Project	IEEE 802.16 Broadband Wireless Access Working Group http://ieee802.org/16 >		
Title	Corrections for AAS in OFDMA PHY		
Date Submitted	2004-08-31		
Source(s)	Tal Kaitz, Ran Yaniv	Alvarion	tal.kaitz@alvarion.com, ran.yaniv@alvarion.com
	Adam Kerr, Paul Petrus, Todd Chauvin	ArrayComm Inc.	adam@arraycomm.com, petrus@arraycomm.com, chauvin@arraycomm.com
	Uri Perlmutter, Hassan Yaghoobi	Intel Corp	uri.perlmutter@intel.com, hassan.yaghoobi@intel.com
	In-Seouk Hwang, Jaehee Cho, Janghoon Yang, Panyuh Joo, Soon Young Yoon, Jaeho Jeon	Samsung Electronics Co.	panyuh@samsung.com
Re:	IEEE P802.16-REVd/D5		
Abstract	This contribution introduces corrections for support of AAS in the OFDMA PHY		
Purpose	Adopt into P802.16d/D5 corrigenda		
Notice	This document has been prepared to assist IEEE 802.16. It is offered as a basis for discussion and is not binding on the contributing individual(s) or organization(s). The material in this document is subject to change in form and content after further study. The contributor(s) reserve(s) the right to add, amend or withdraw material contained herein.

Corrections for AAS in OFDMA PHY

8.4.4.6.1 AAS frame structure

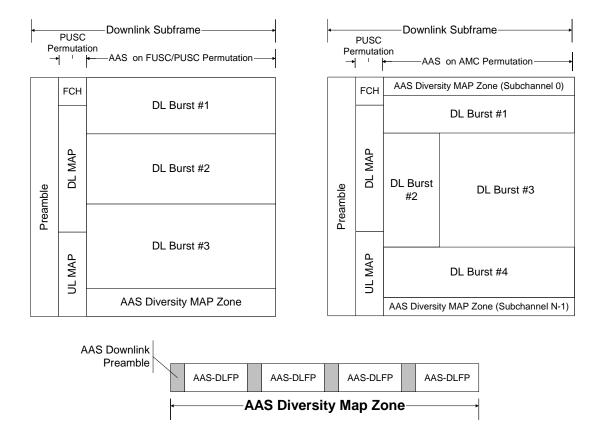
The AAS DL Zone begins on a symbol boundary and consists of all subchannels until the beginning of the UL subframe for TDD or until the end of the frame for FDD. The two highest numbered subchannels of the AAS DL Zone frame may be dedicated at the discretion of are dedicated by the BS for the AAS Diversity-Map Zone in the PUSC, FUSC and optional FUSC permutation. For the PUSC permutation, it is assumed that all AAS subscribers can decode the FCH in order to know the Used Subchannel Bitmap. In the AMC permutation, the 4th and (N 4)th first and last subchannels of the total N subchannels of the AAS DL Zone frame may be dedicated at the discretion of are dedicated by the BS for the AAS Diversity-Map Zone. For AMC permutation, each subchannel for the AAS diversity MAP consists of 3 bins by 2 symbols. When these subchannels are used for this purpose, they shall not be otherwise allocated in the normal DL-MAP messages. and shall be used only on the AAS portion of the DL sub-frame. These sub-channels will be used to transmit the AAS-DLFP() whose physical construction is shown in Figure 223.

[Replace figure 224 with the following]
